PLANS AND DOCUMENTS referred to in the DEVELOPMENT APPROVAL

Application No: MCU/2022/291

LOT 11 PROXIMITY PLACE, STAYPLTON

N	27.07.22	AMENDED DA RFI ISSUE	AR												
						M	26.07.22	DA RFI ISSUE	AR												
						L	02.06.22	DA ISSUE	AR												
						K	11.05.22	GRID ADDED	AR												
						PROJECT DESCRIPTION: WAREHOUSE & OFFICE								DRAWING TITLE(S): SITE PLAN				PROJECT NUMBER: 5001		PROJECT START DATE: 15.03.2021	
																		PROJECT STAGE: SK		DRAWING NUMBER: -AR-1001

1 SITE PLAN
1:200

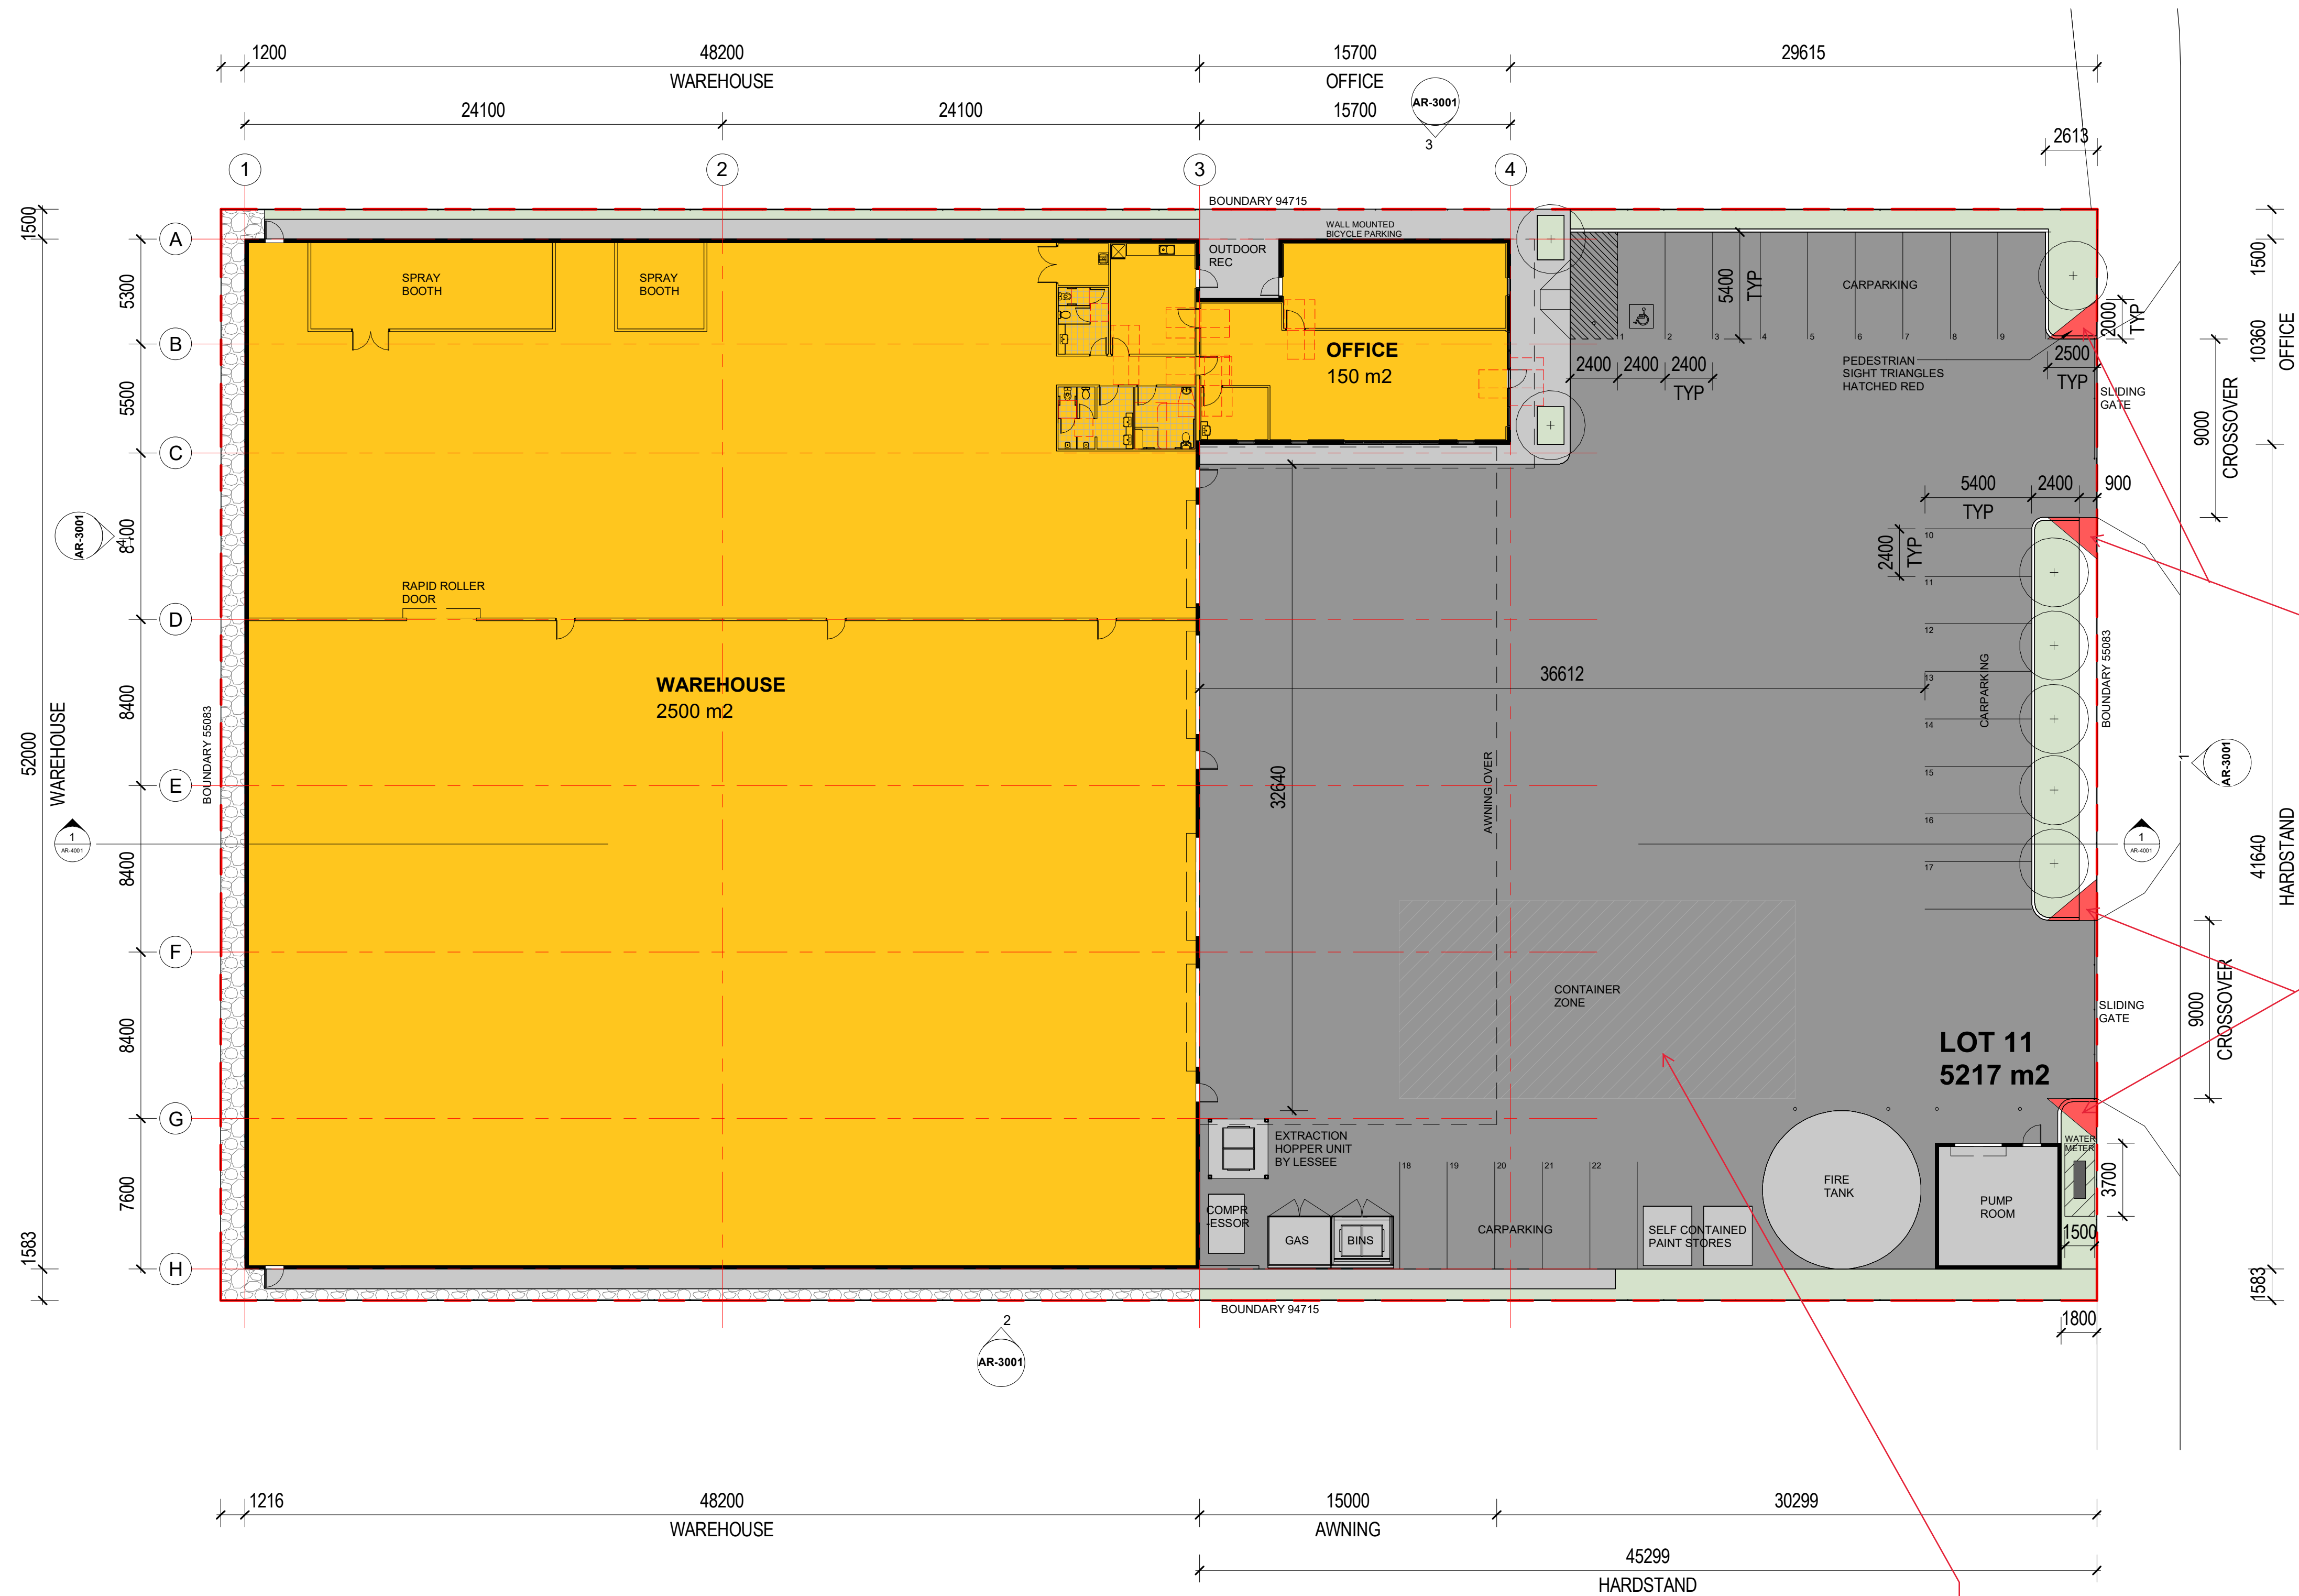
Amended in red by Council - Pedestrian sight triangles to be kept clear of obstructions to visibility. Low level landscaping permitted to a maximum mature height of 500mm above driveway level"

Amended in red by Council - To be used for storage of container/s for maximum 24 hours from time of delivery, once per week.
